## DEVELOPMENT APPLICATION ASSESSMENT REPORT

Application Number:	DA2023/0083
---------------------	-------------

Responsible Officer:	Thomas Prosser
Land to be developed (Address):	Lot 9 DP 17704, 24 Cabarita Road AVALON BEACH NSW 2107 Lot LIC 396153, 24 Cabarita Road AVALON BEACH NSW 2107 Lot LIC 631604, 24 Cabarita Road AVALON BEACH NSW 2107
Proposed Development:	Demolition works and construction of a dwelling house including swimming pool and boatshed
Zoning:	C4 Environmental Living
Development Permissible:	Yes
Existing Use Rights:	No
Consent Authority:	Northern Beaches Council
Delegation Level:	NBLPP
Land and Environment Court Action:	No
Owner:	Elizabeth Mary Macdiarmid Bruce Ian Macdiarmid
Applicant:	Elizabeth Mary Macdiarmid Bruce Ian Macdiarmid

The application involves demolition of the existing dwelling and construction of a part two/part three storey dwelling-house with a boatshed, swimming pool and landscaping.

**Figure 1. Section showing height above 8.5m as prepared by applicant**

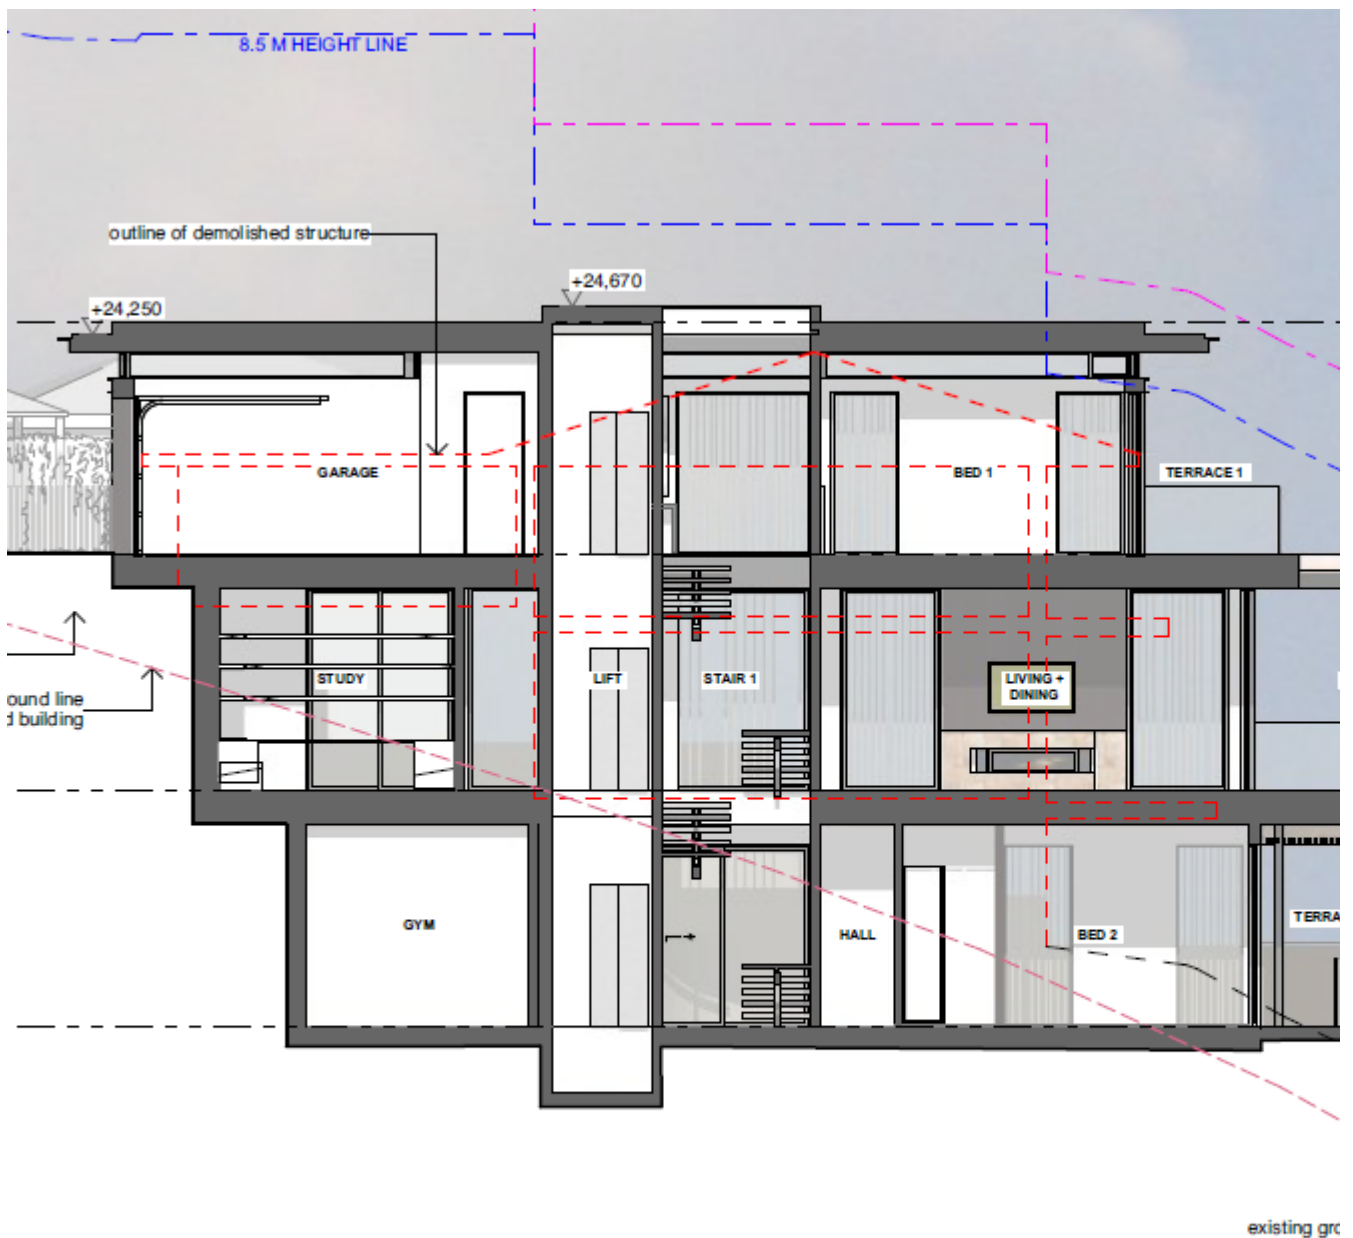
The proposed variation is limited to a minor portion of the building, being the roof overhang above the blue dotted line as shown below:

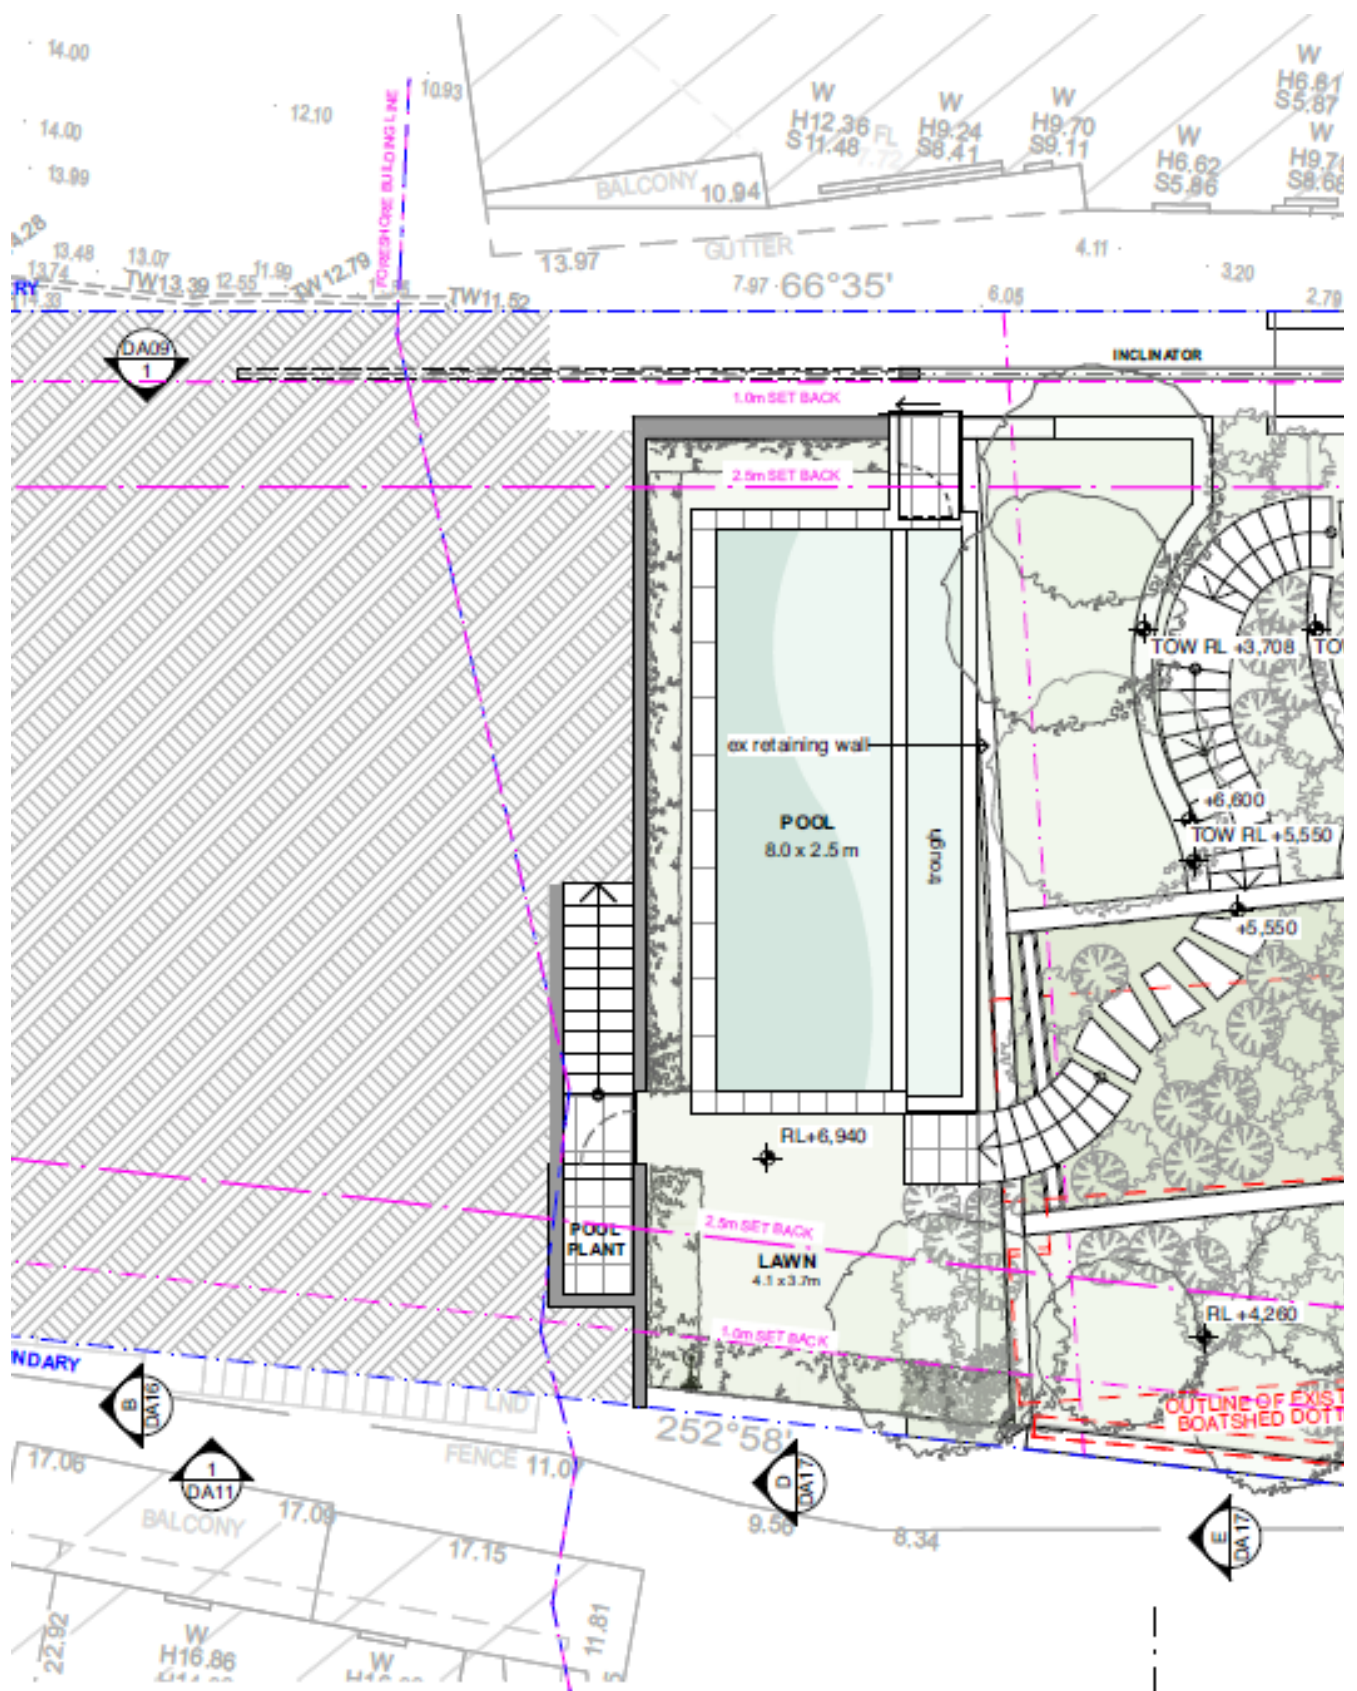
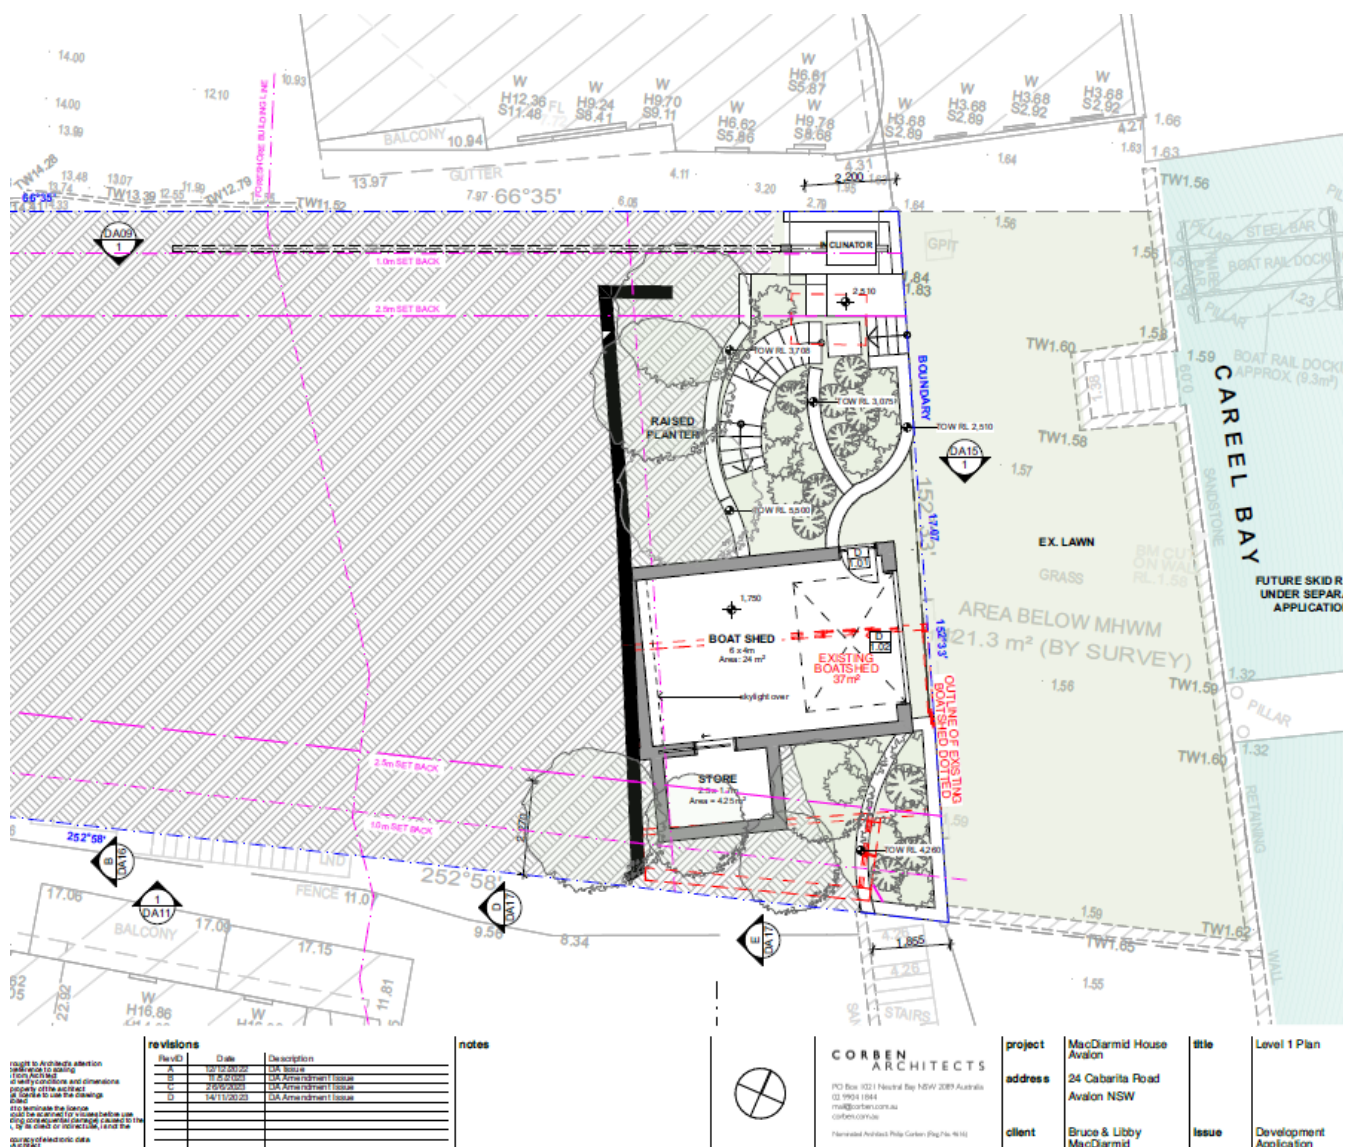
The proposed works that necessitate a Clause 4.6 written request include; retaining walls, a store and the replacement of the existing inclinator.

The images below show the works within the Foreshore Area (noting the Foreshore Building Line is the purple dotted line with the notation at the top of the image):

**Figure 1: Representation of Side boundary envelope non-compliance at North Elevation**

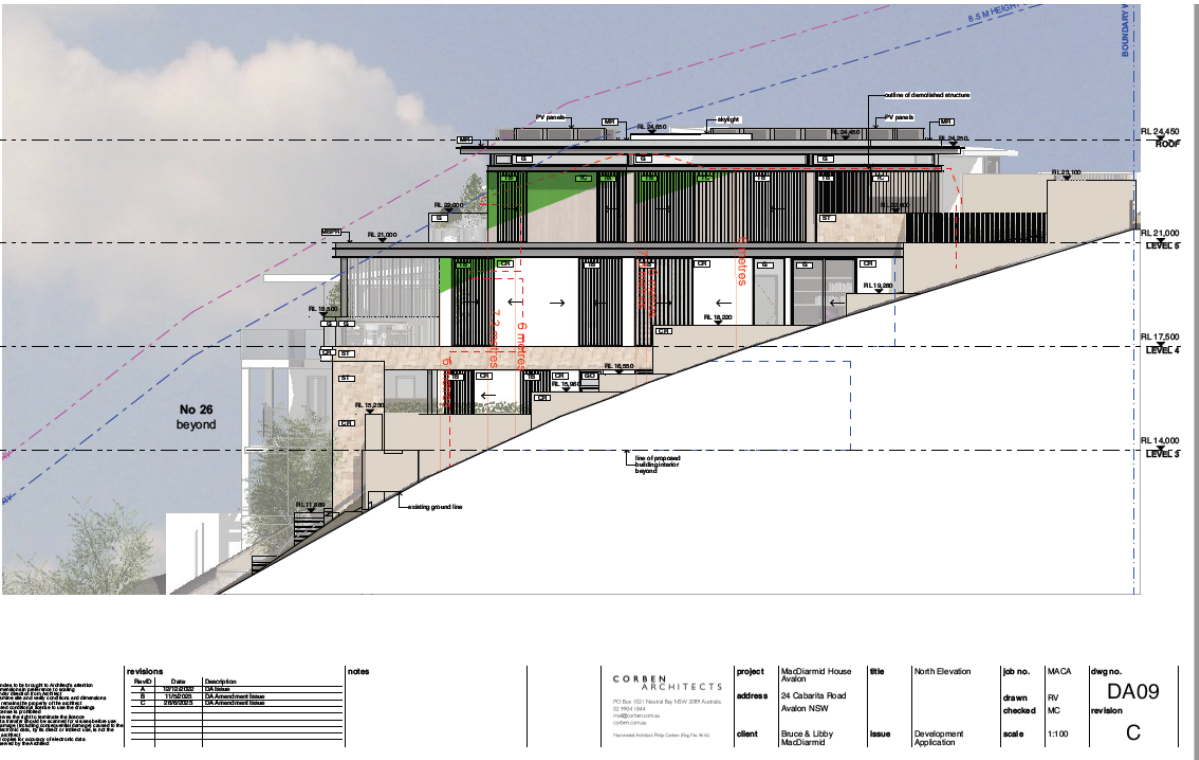
The proposal does not comply with the side boundary envelope control as demonstrated in the images below:
